Residences of South Brookline Transportation Peer Review Responses

I. Peer Review (BETA) : Received 3/21/14

Crash Locations – 2011 through 2013 Brookline Police Department Records

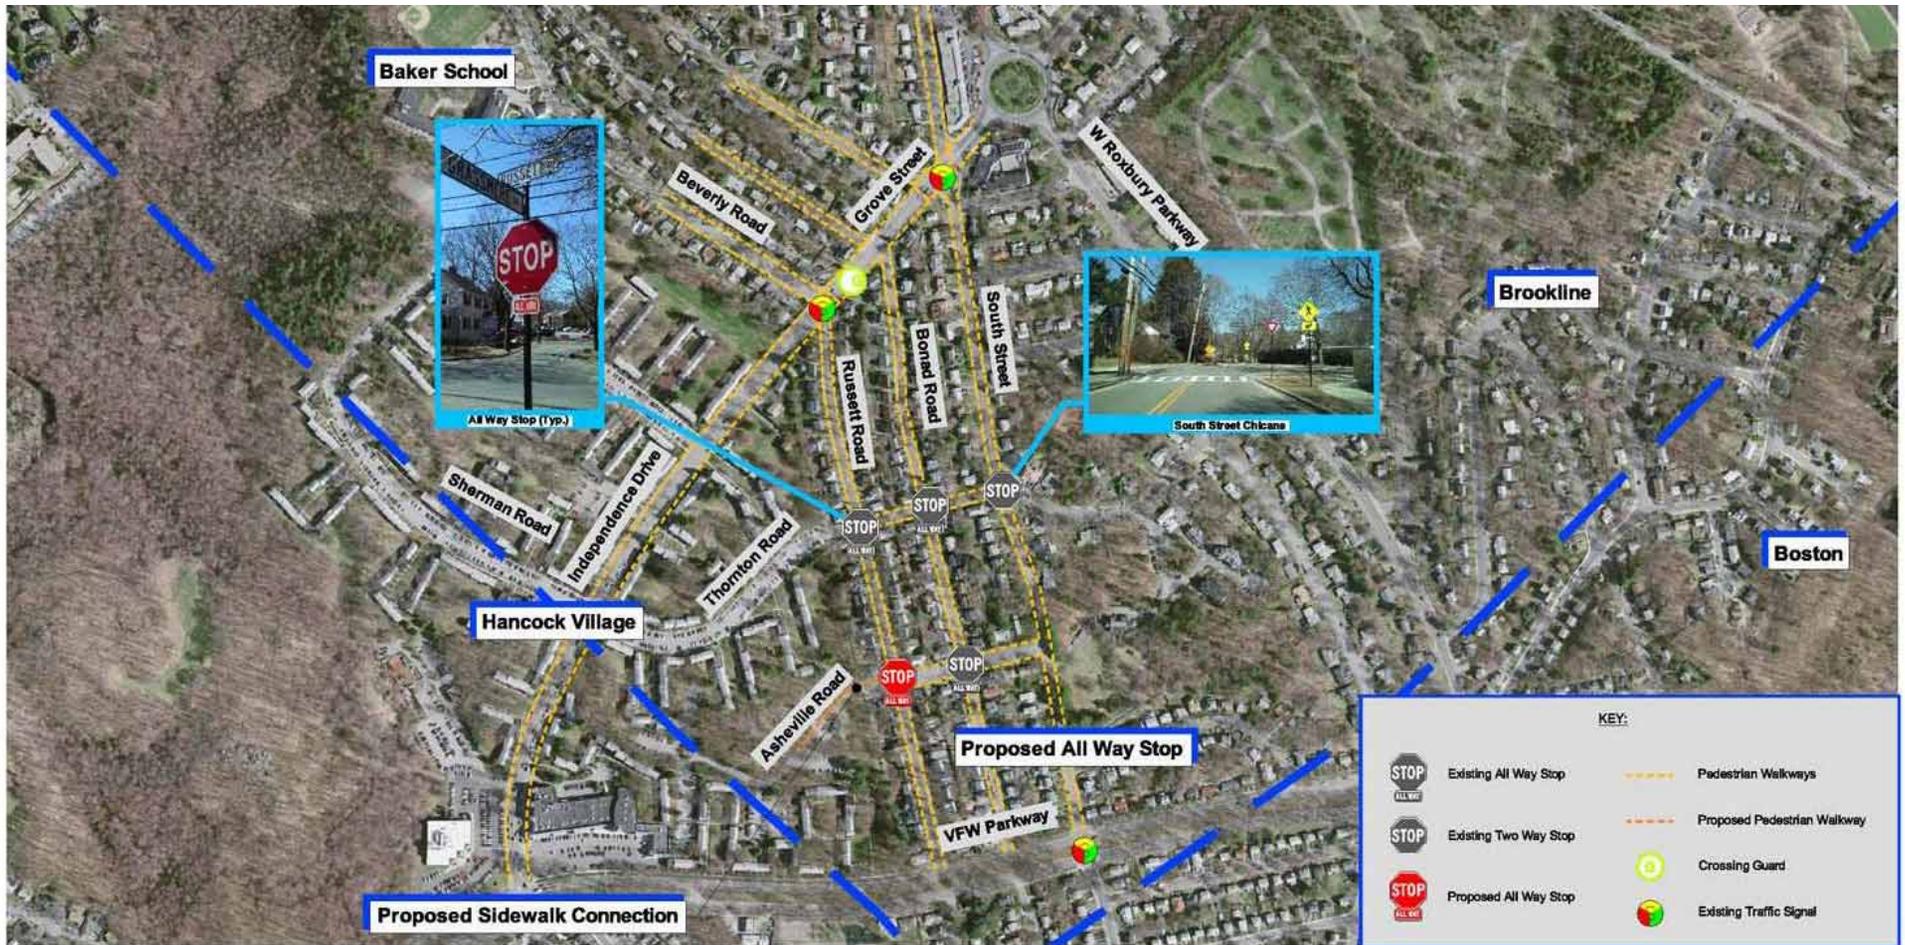
#6 – Police Department Crash Records

- A supplemental crash analysis has been conducted based on Brookline Police Department crash records with results that are generally consistent with the crash analysis based on MassDOT crash data.
- No safety deficiencies were identified.

Neighborhood Traffic Controls & Facilities

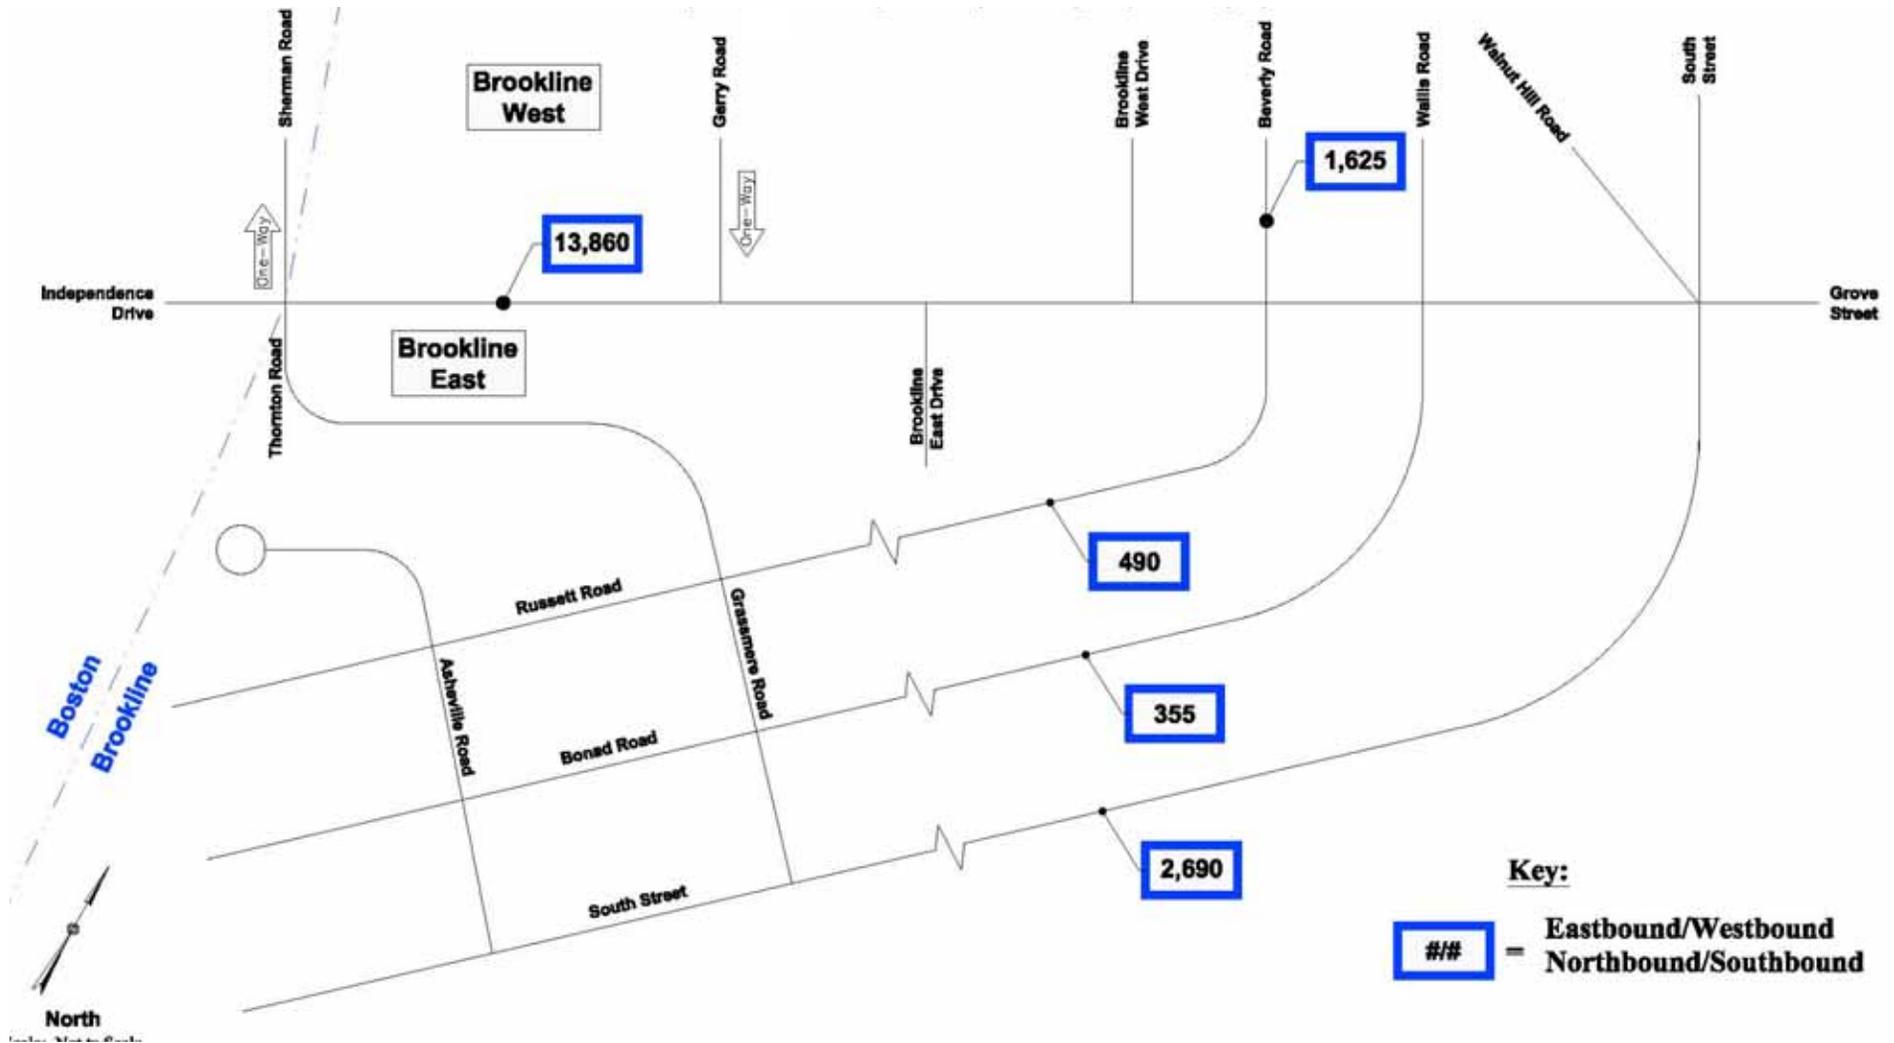
#8 – Traffic Calming

- The Town has implemented traffic calming measures in the adjoining neighborhood.
- Additional traffic calming measures beyond those already in place are not warranted along Asheville Road, Russett Road or South Street based on review of crash records, traffic volume data and travel speeds.

AM Peak Hour Site-Generated Trips

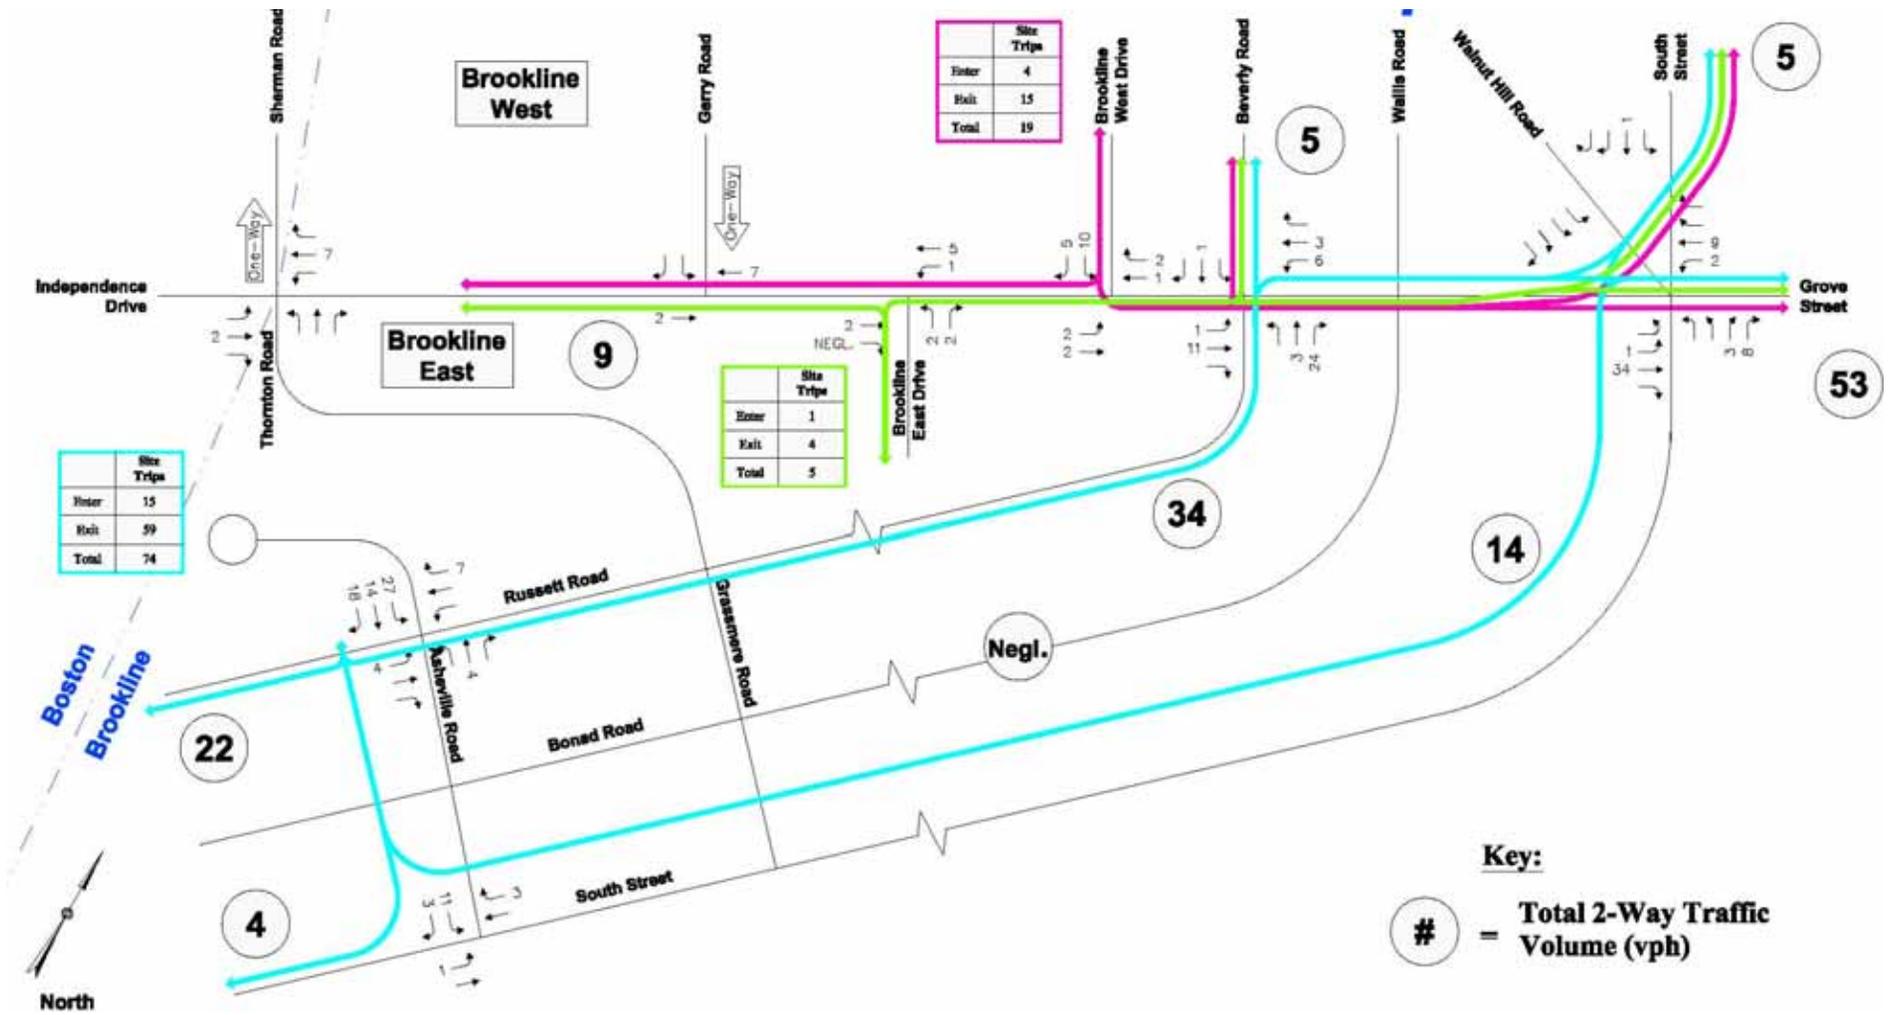
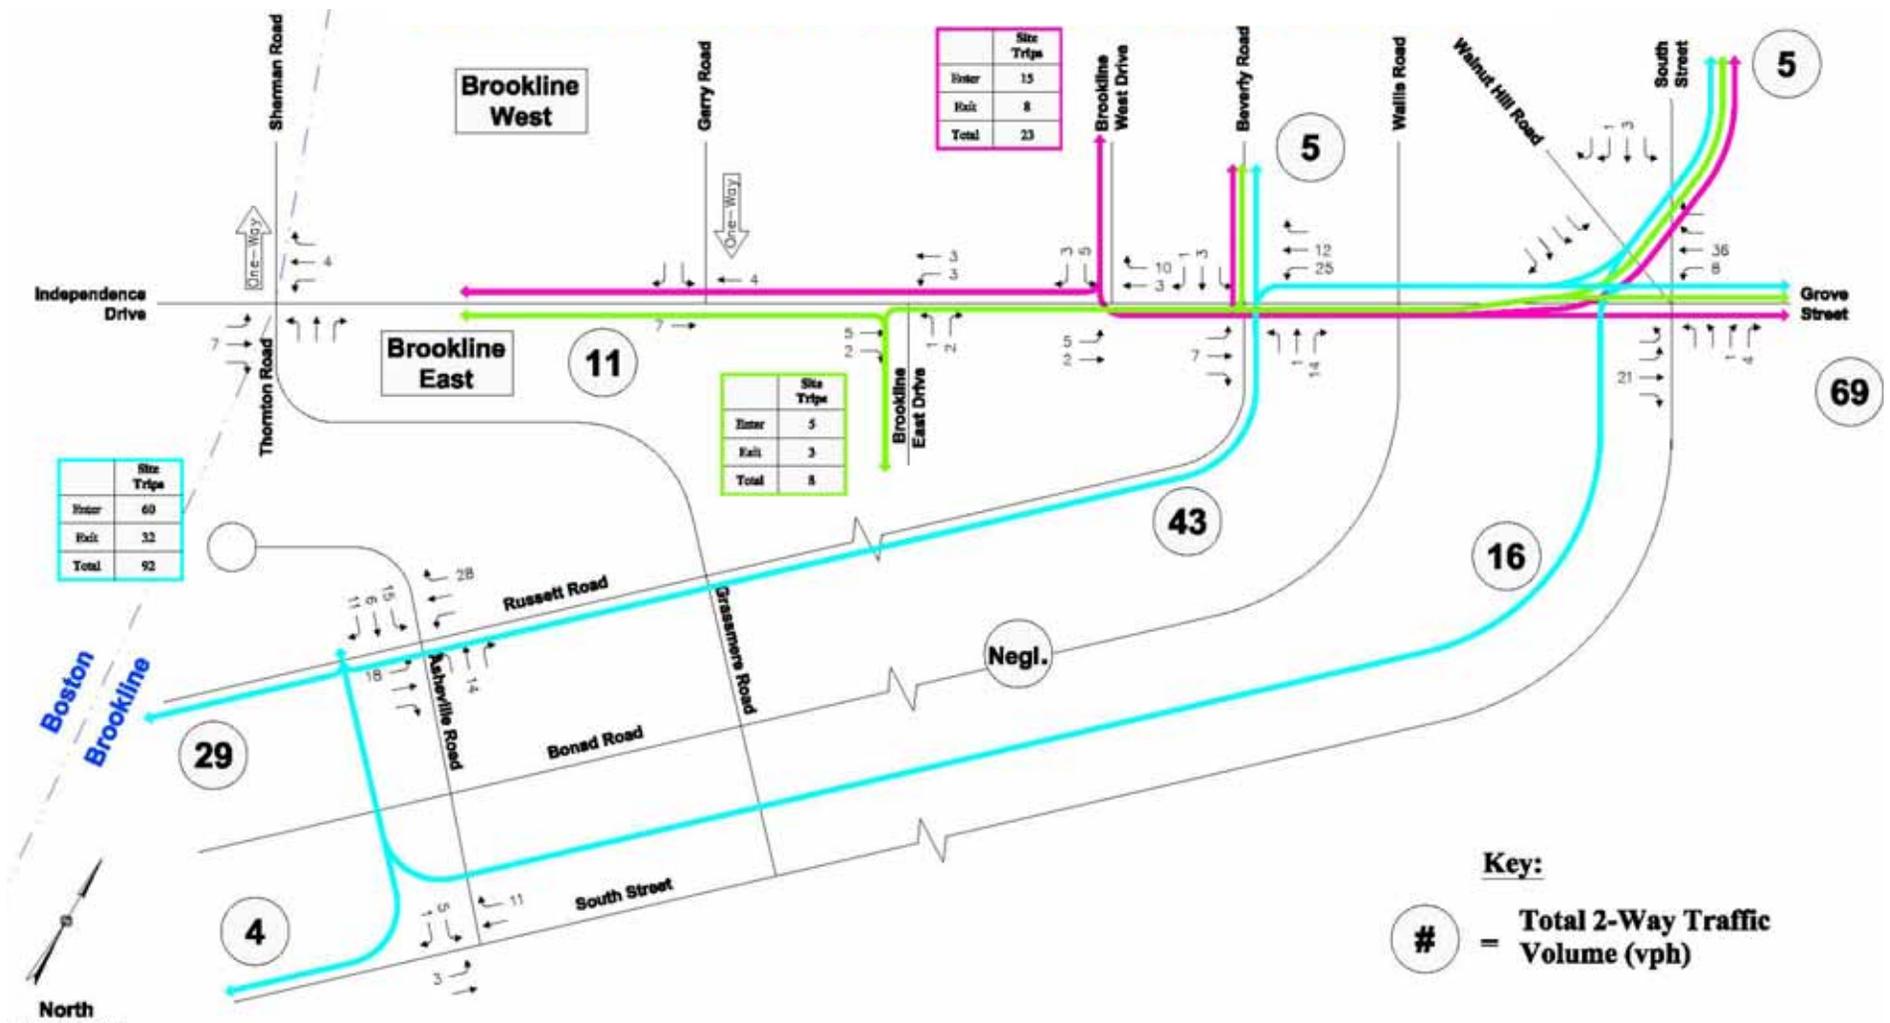
#9 – Trip Distribution

- The trip distribution methodology is appropriate.
- The patterns reflect existing trends for Hancock Village.
- Trip increases in the neighborhood streets are modest.

Intersection Operation – Build Condition (No Change)

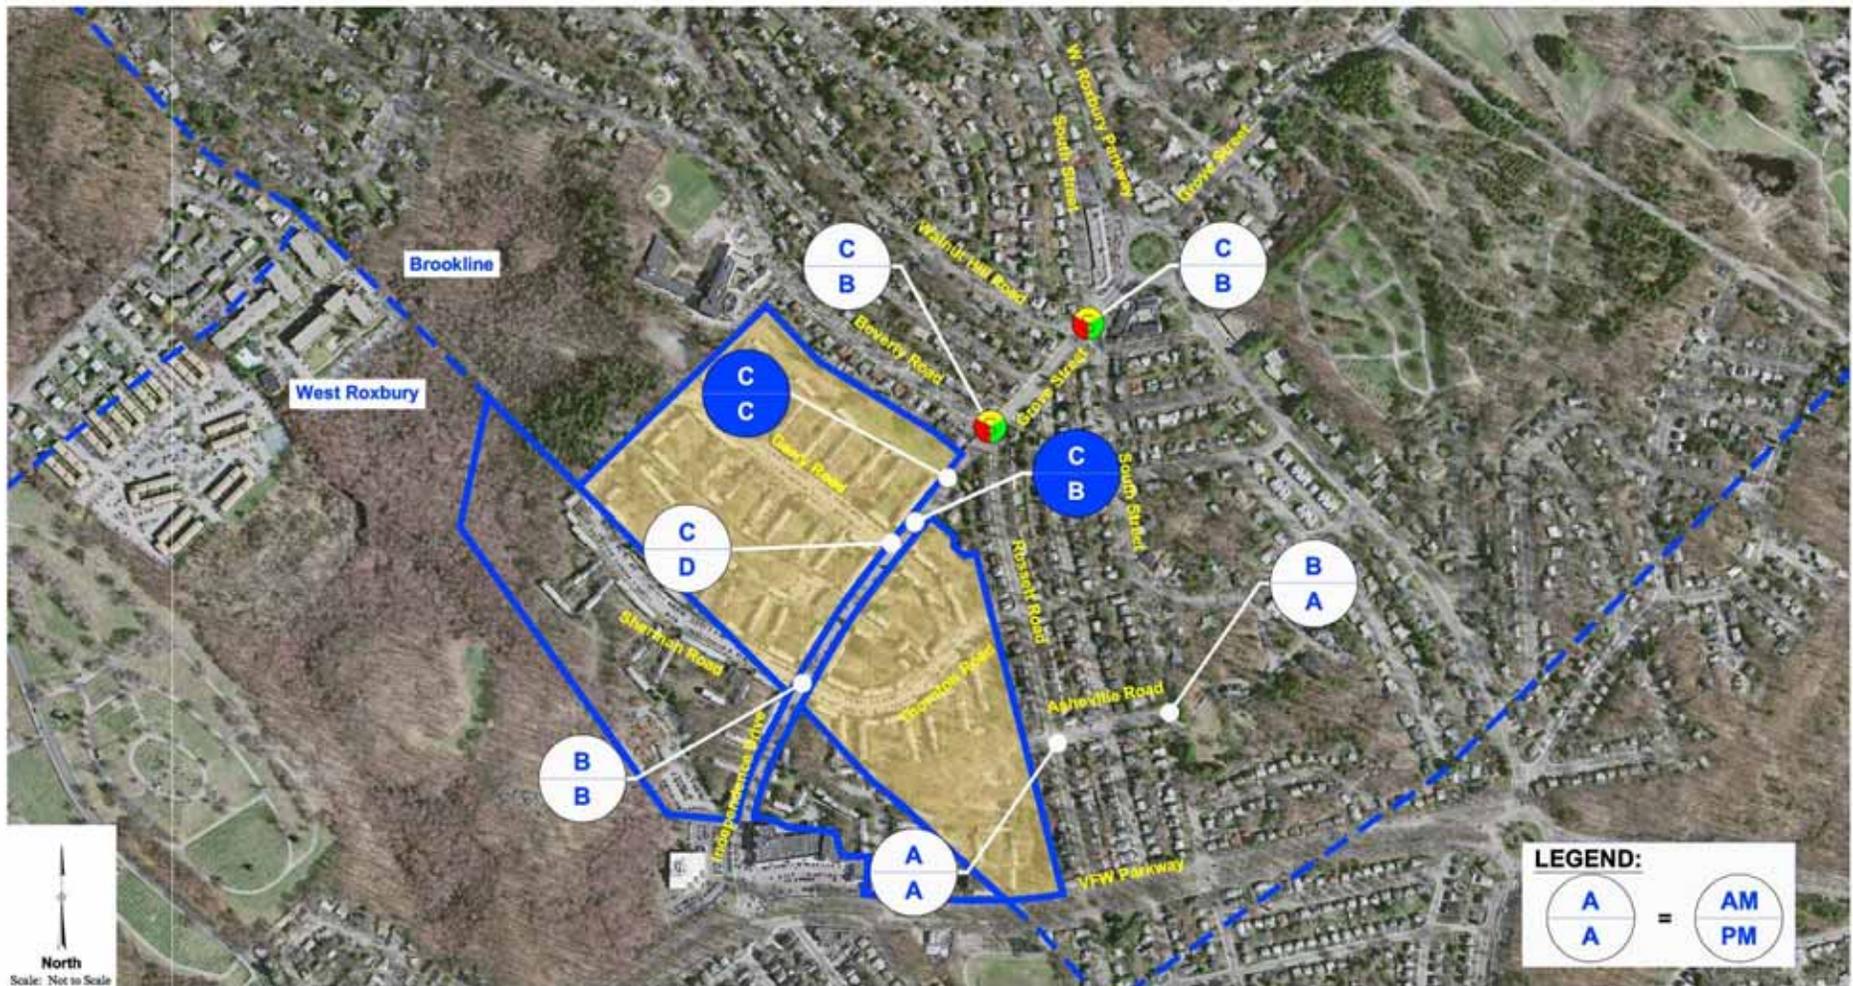
#10 – Capacity Analysis

- The capacity analysis was conducted in accordance with industry standards using valid traffic volume data.

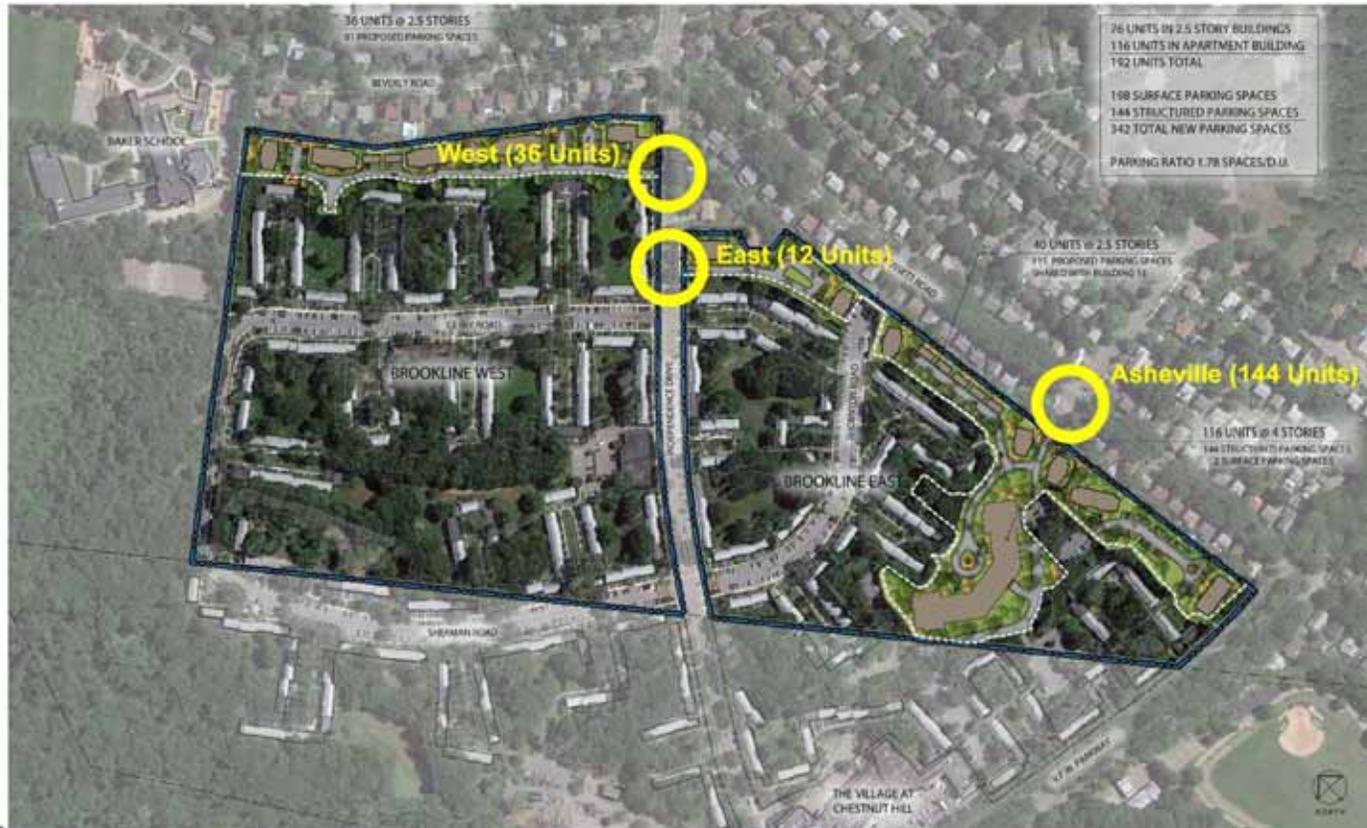
#11 – Multiple Access Points

- The use of multiple driveways will result in less traffic impact.
